UNITED STATES PATENT AND TRADEMARK OFFICE

Office Action Summary

10/724,754

DETAILED ACTION

Figure A. Prior art of Schroter.

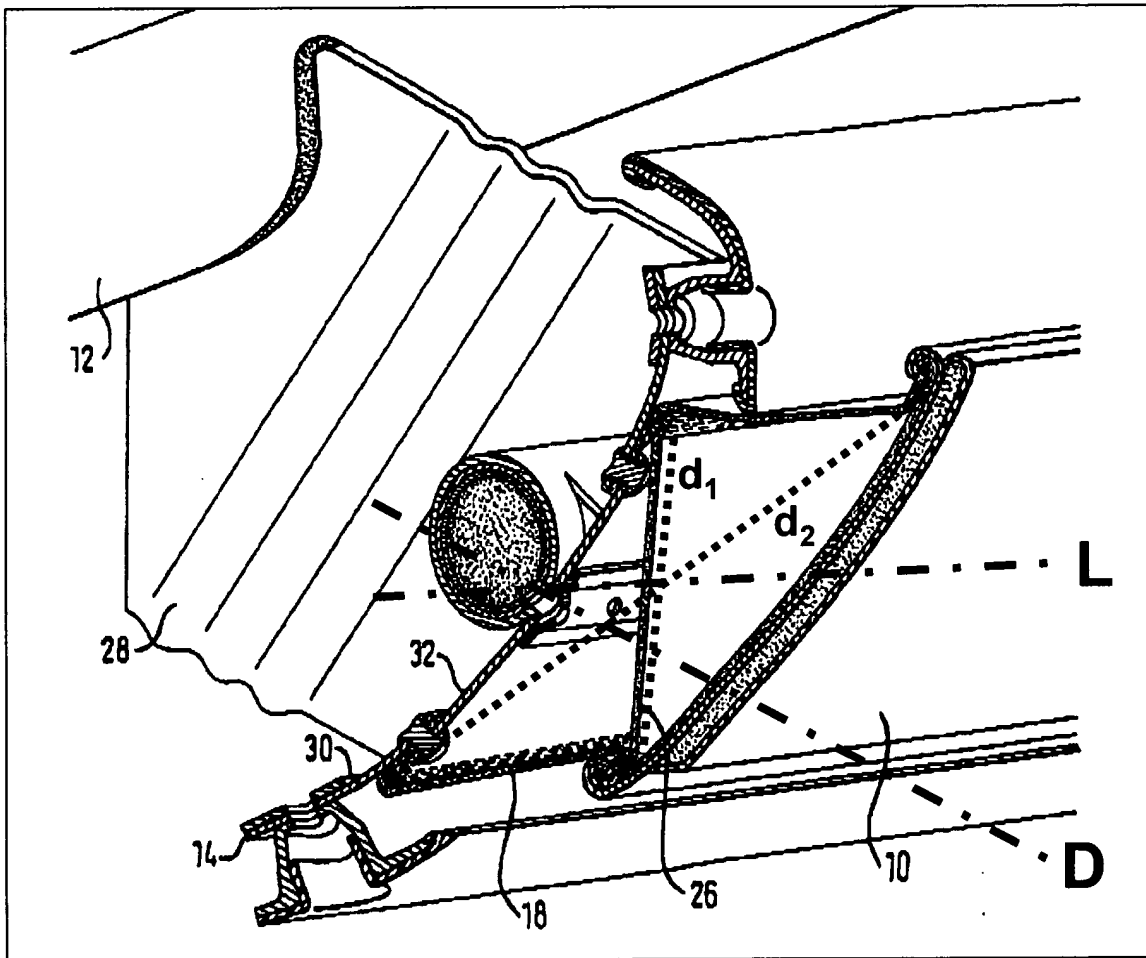
direction of inflation in order to deploy it, a plate 10 for spreading the load when an occupant of the vehicle impacts on the deployed inflatable structure, means of guiding the structure as it deploys so that, in the deployed configuration, the structure extends along a median directrix line distinct from the direction of inflation wherein the guide means comprise the side wall 18 of the structure which, in the deployed configuration, is substantially taut as shown in Figure A below (claim 1.)

b. The side wall 18 of the structure has a first diagonal d_1 shorter than a second diagonal d_2 of the side wall so that, as the structure deploys, the side wall which is substantially taut along the first diagonal brings the structure towards the median directrix line as shown in Figure A below (column 1, line 56 – column 2, line 11) (claim 2.)

c. When the structure is in the deployed configuration, the side wall 18 extends substantially over its entire periphery along generatrices parallel to the median directrix line L as shown in Figure A below (Fig. 4) (claim 4.)

- d. The median directrix line L is intended to be inclined upwards with respect to the direction of inflation D when the set of equipment is installed in a motor vehicle as shown in Figure A (Fig. 4) (claim 5.)
